As from serial number 200905001, several updates are implemented on DM 230

In this Service bulletin, the major changes are described.

2. Slip clutch.

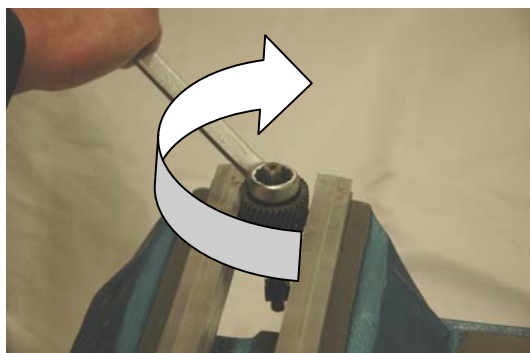
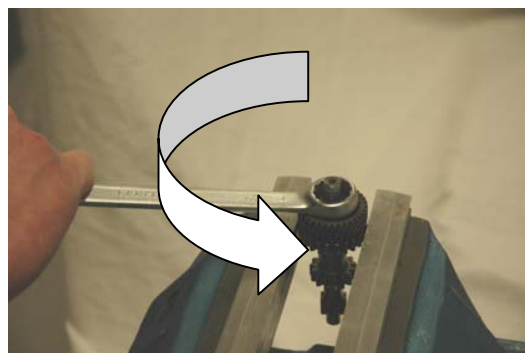
There is a new routine for slip clutch adjustment.

When you are adjusting the slip clutch torque, first tighten the nut to the mechanical stop. Then go back 45°. Now the clutch should slip at a minimum torque of 17 Nm (15 Nm or 11 lbf/ft in USA). If not, replace the spring and friction washers. These can be ordered in a complete kit.

Tighten the nut to the mechanical stop.

Go back 45°.

Check the torque. If it less then 17 Nm (15 Nm USA), replace the Kit Wear Parts.

If the torque is higher, you need to adjust to the correct figure.

Kit Wear Parts. Part No. 525 40 20-01.

3. The upper gear wheel on the intermediate shaft.

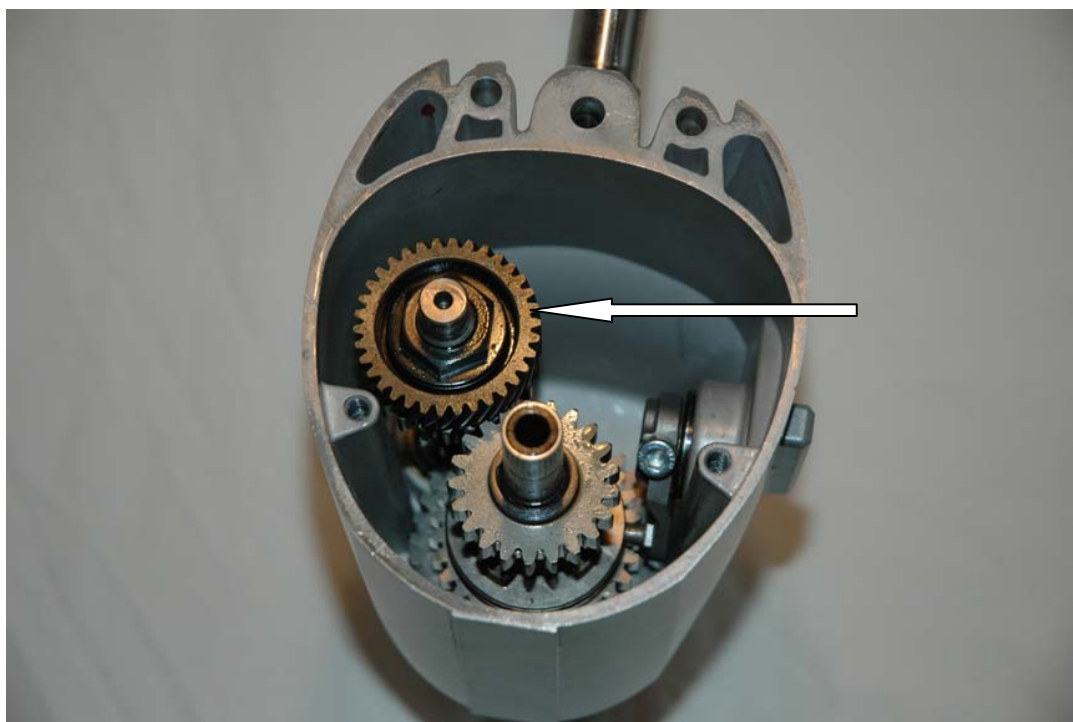
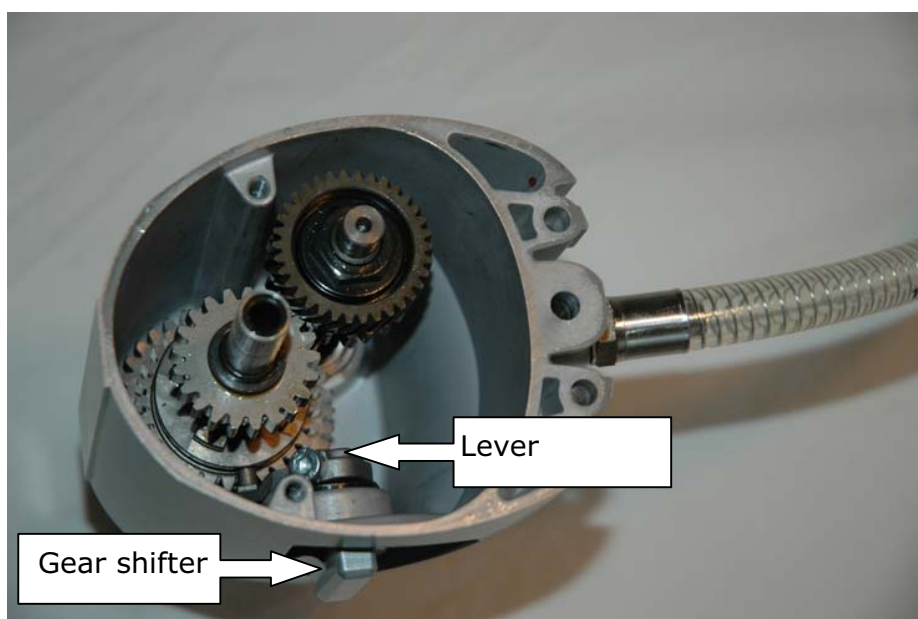
The old gear wheel and its bushing were sold in a kit.

This gear wheel is now improved.

This modification is fully backward compatible.

The new gear wheel is punched with the part no. This is to avoid mix up with previous version

The new kit has Part No. 504 57 11-02.

6. Water connection.

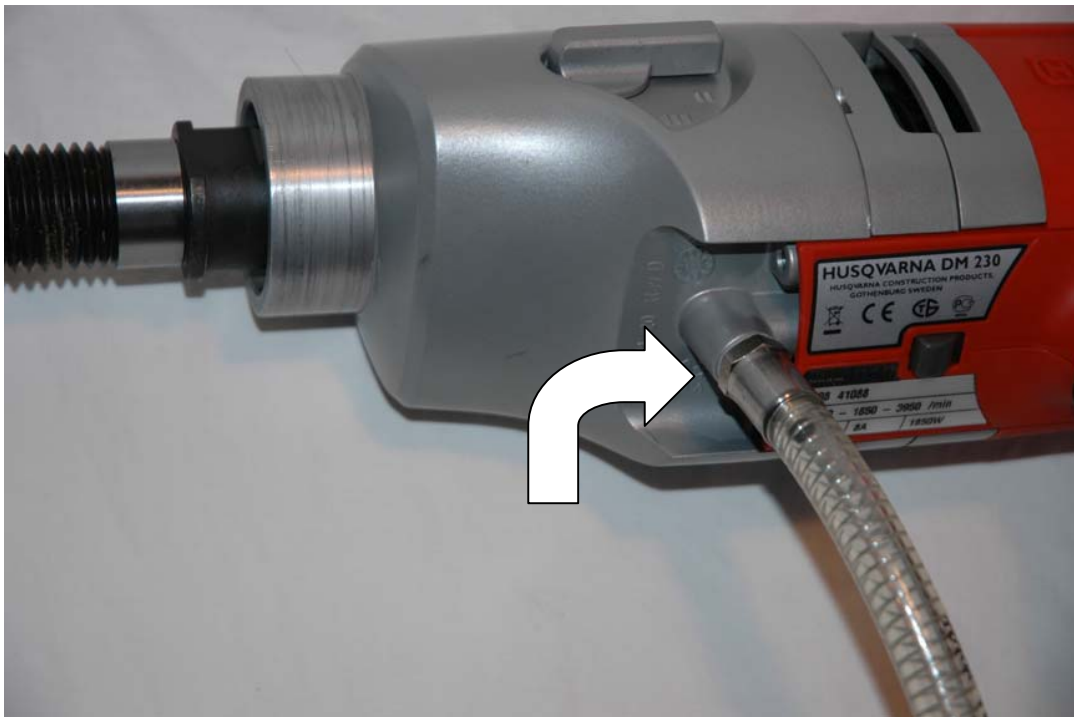
Changes on the water connection to the Gear housing (544 11 20-01).

The washer between the gear housing and water house is no longer used.

Two different washers have been used.

The fibre washer (531 07 42-60) or aluminum gasket (525 33 97-01)

Today the water connection is sealed with Loctite 243.
